ADDENDUM TO REPORT FOR ITEM LPP05 DATED 1 JUNE 2021

SUBJECT: 15 WAIWERA STREET, LAVENDER BAY

APPLICATION NO. DA 20/21

AUTHOR: HUGH SHOULDICE, ASSESSMENT OFFICER

DRAWING TITLE
Planting Plan - Trees

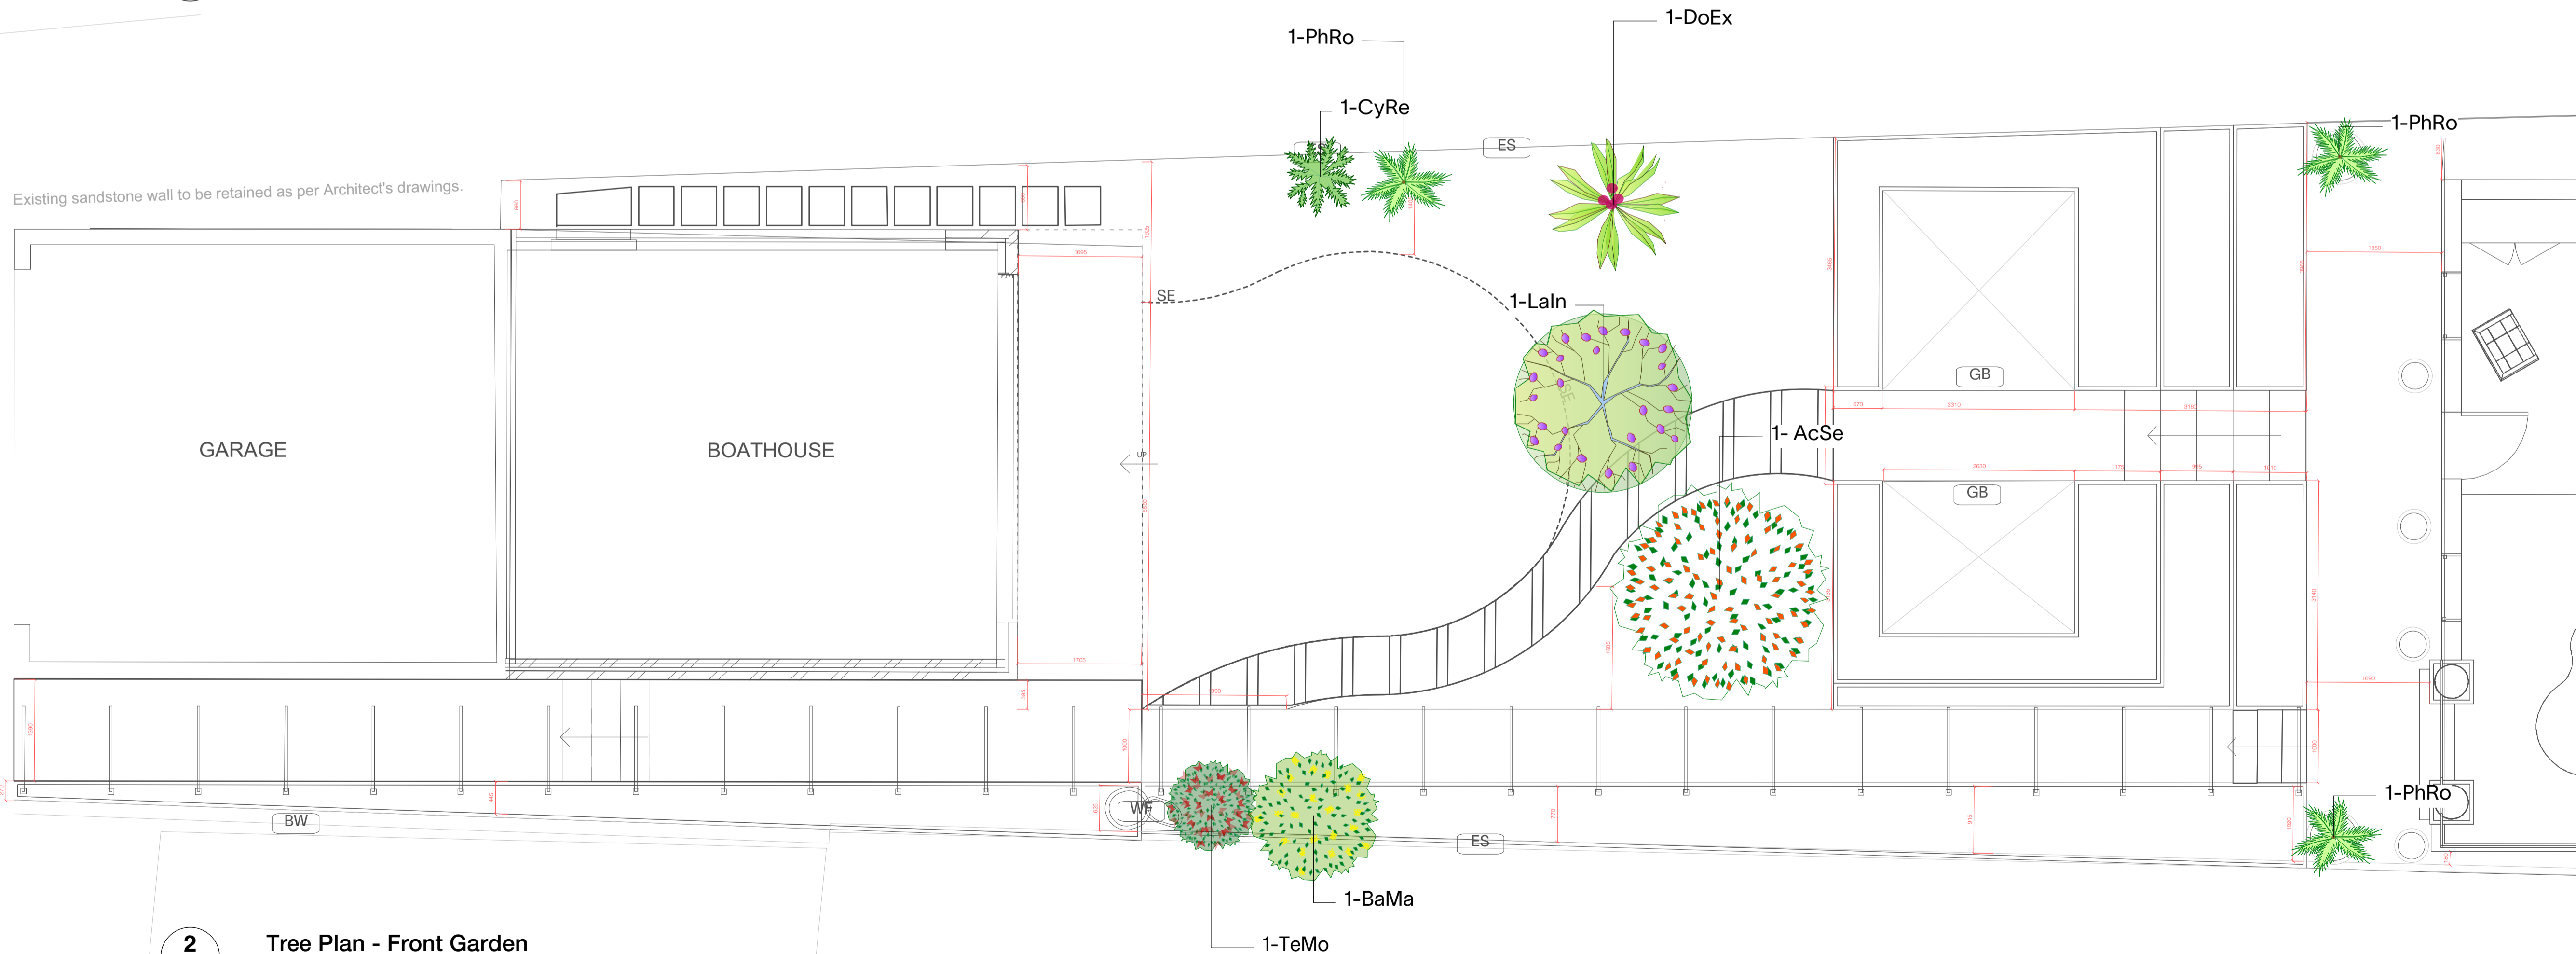
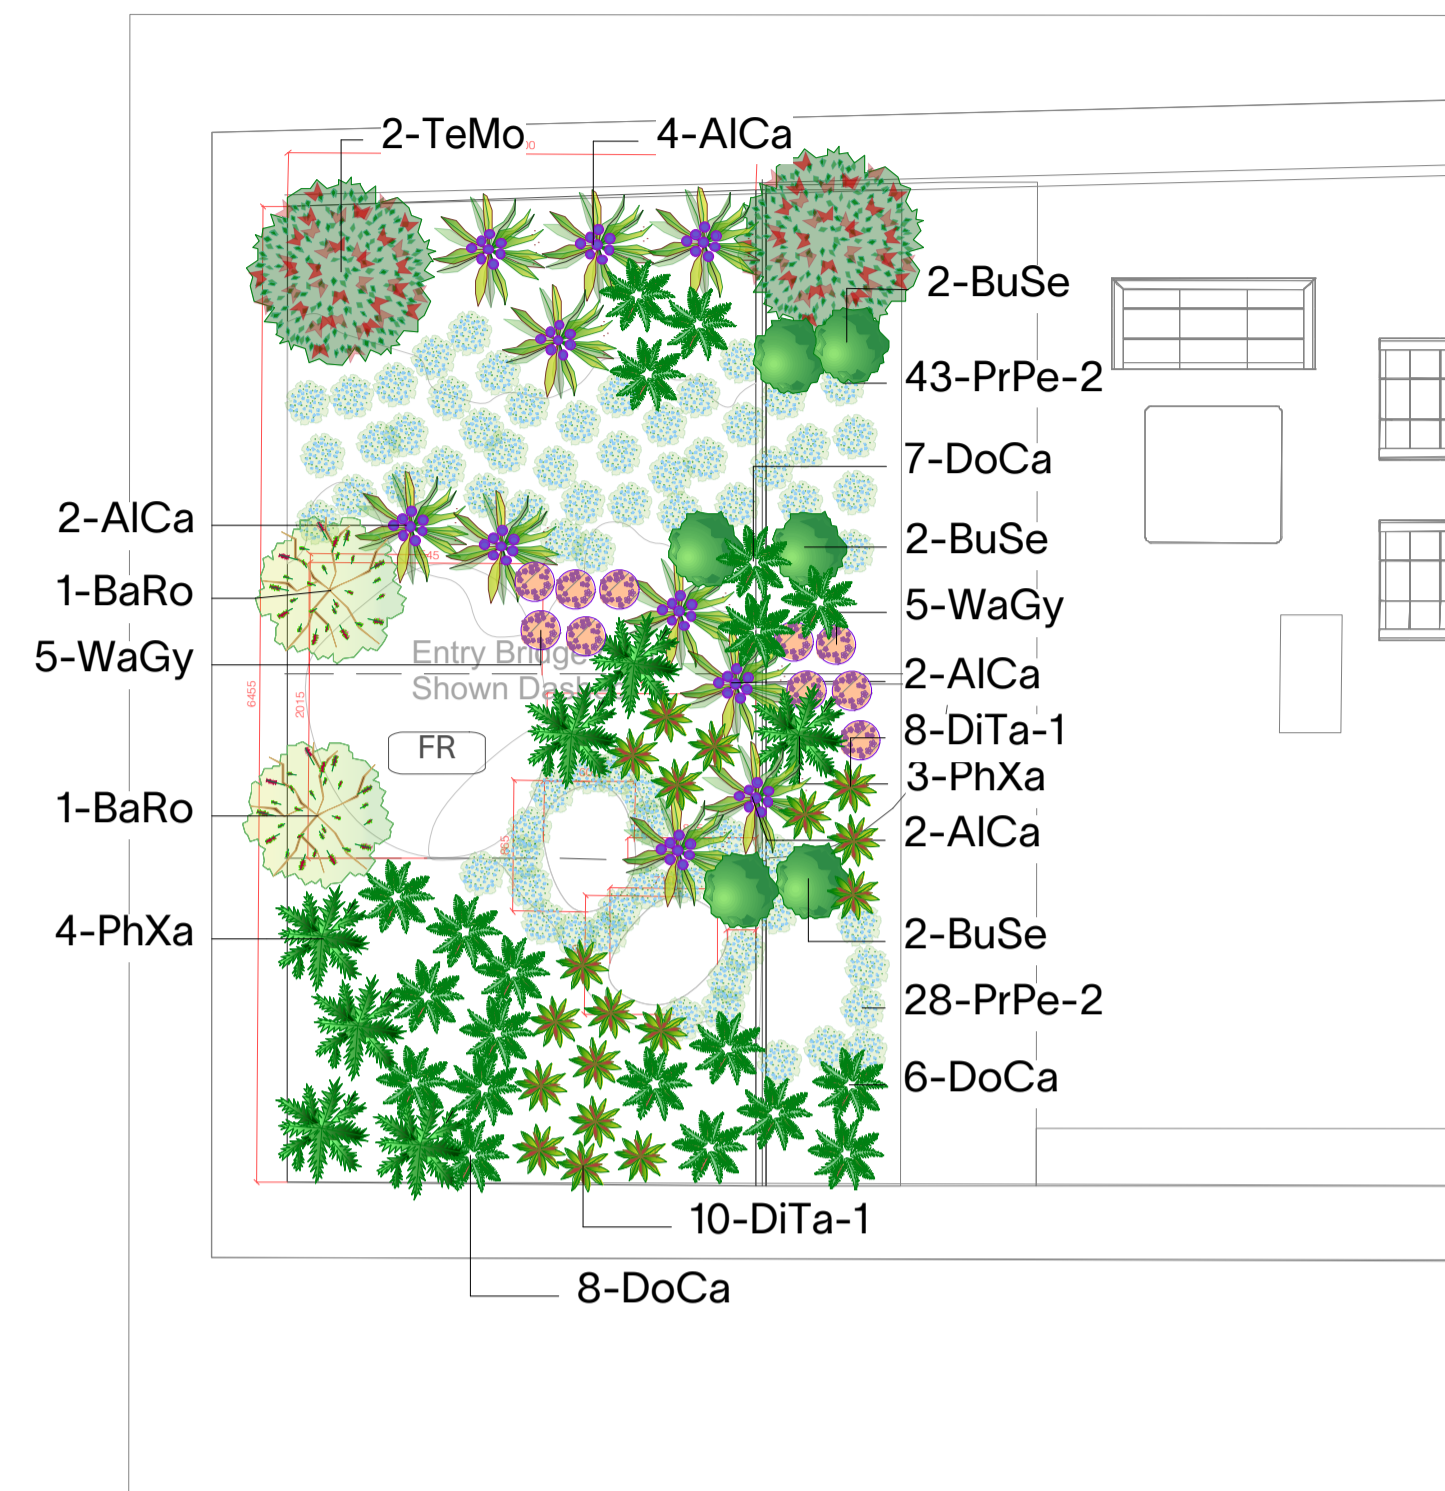
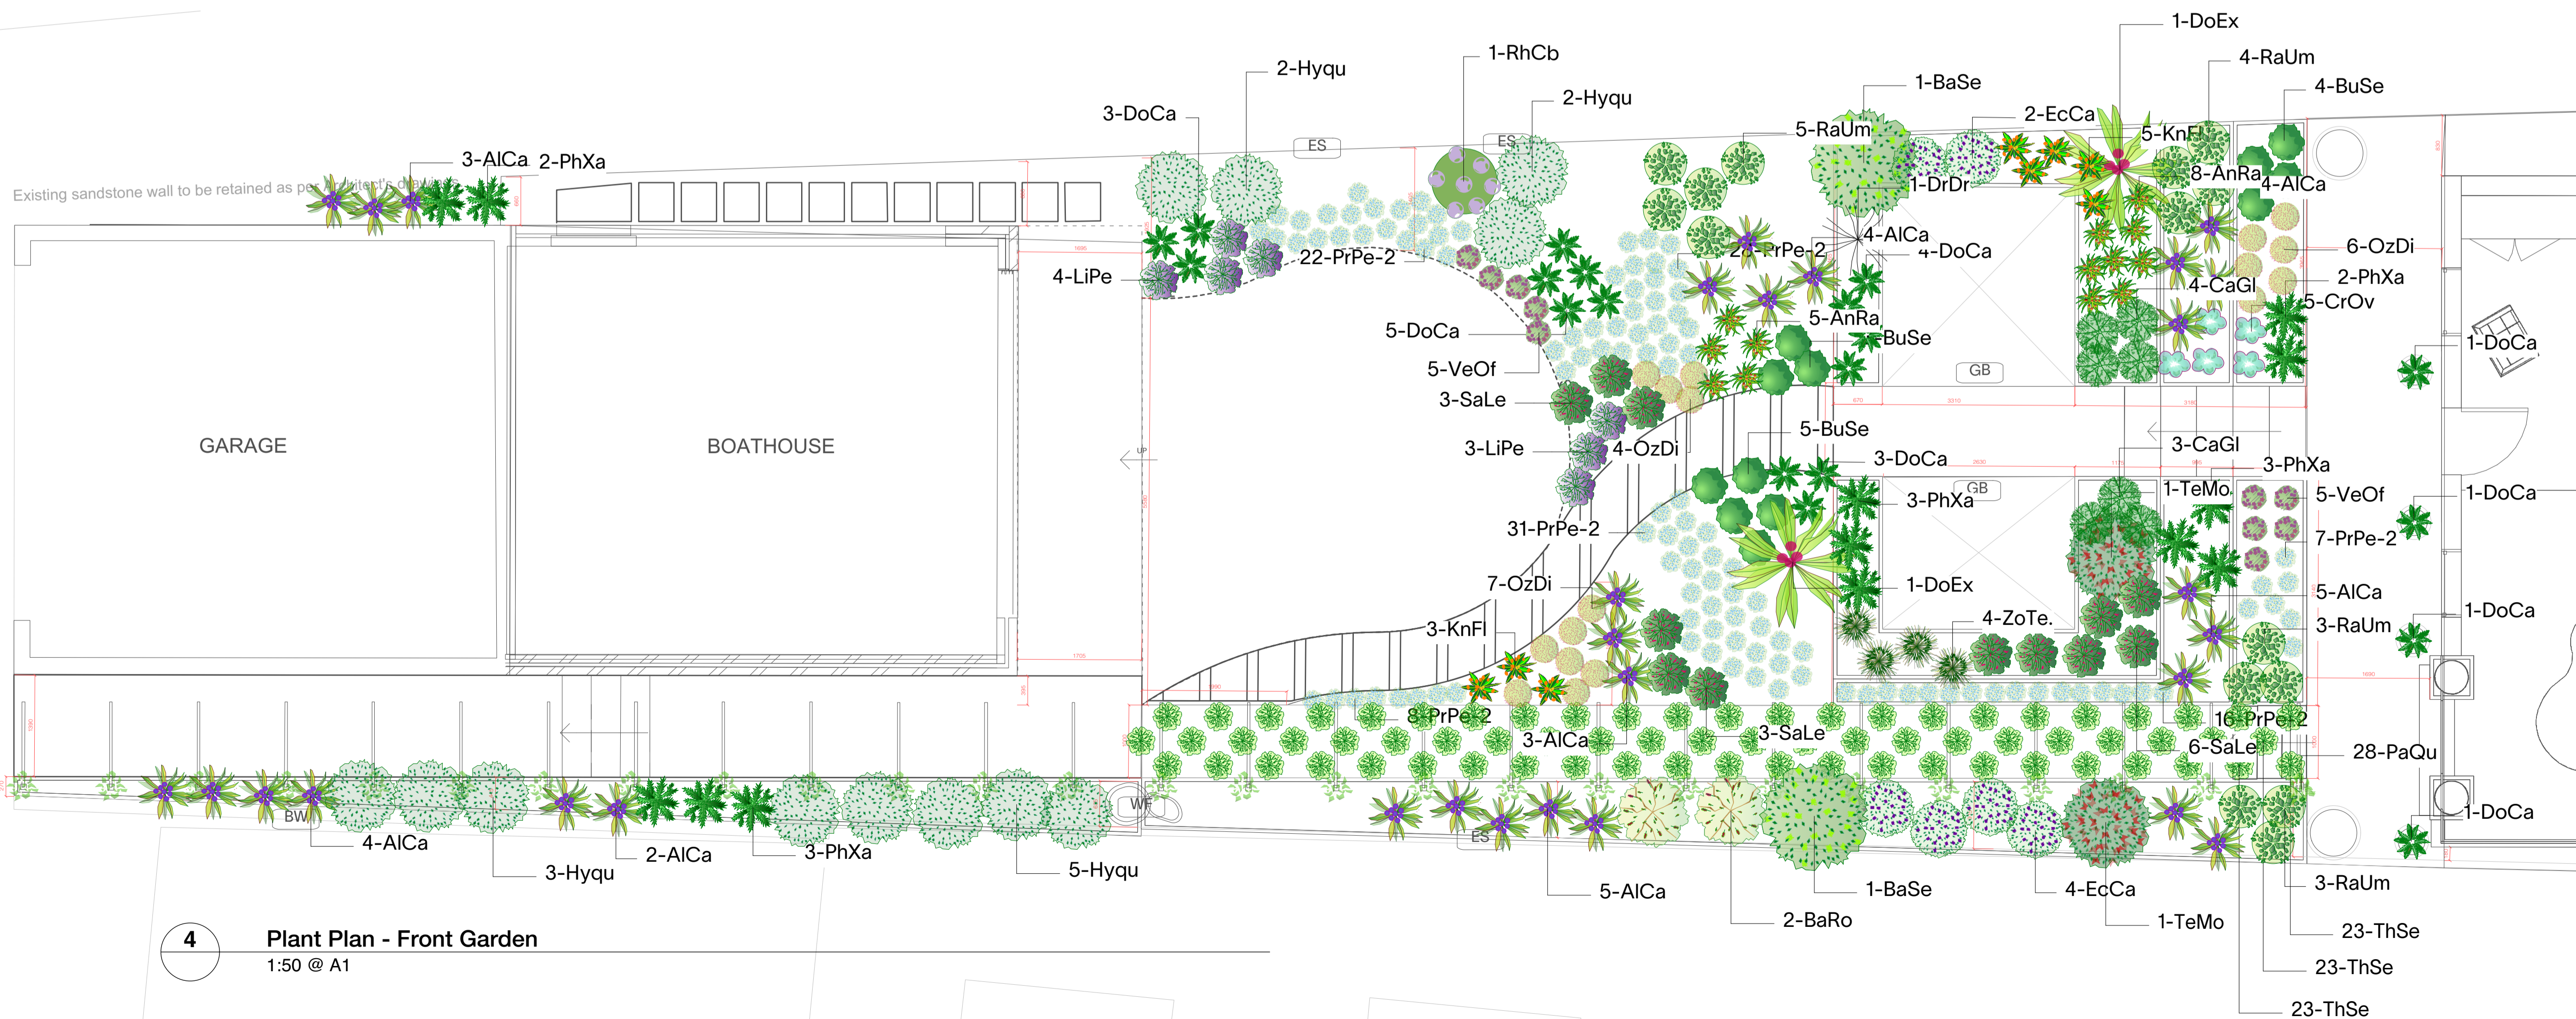
- *The Landscape Plan prepared by Philip Withers dated 18/11/20 is considered to be inaccurate –claiming that a total of 19 new trees are to be planted. The majority of these are claimed to be “trees”. However, they are considered to be small shrubs, palms, ferns or perennials, with only 2 actual canopy trees included in the claimed total of 19 trees (2 x Banksia serrata).*

- *An amended proposal ... that allows for the retention of T2 and T4, includes an amended arborist report with a detailed Tree Protection and Management Plan for same, and an amended Landscape Plan that accurately includes details of all plants is required. It should also ensure that plants chosen are characteristic of heritage plantings, and are not simply chosen due to their status as native plants (NSC while applauding the use of native plants, does not require their use per se, but prefers a planting palette in keeping with all site, locality, and heritage considerations).*

- The existing *Phoenix canariensis* (T4) is shown to be relocated within the subject site.
- A replacement mature *Magnolia grandiflora* (T2) is to be shown planted within the subject site.
- A tree planting schedule is to be provided on each sheet of the landscape plans.
- A heritage consultant with expertise in the landscaped design is to provide written certification that the revised design is consistent with the approved built form and heritage significance of the subject site.
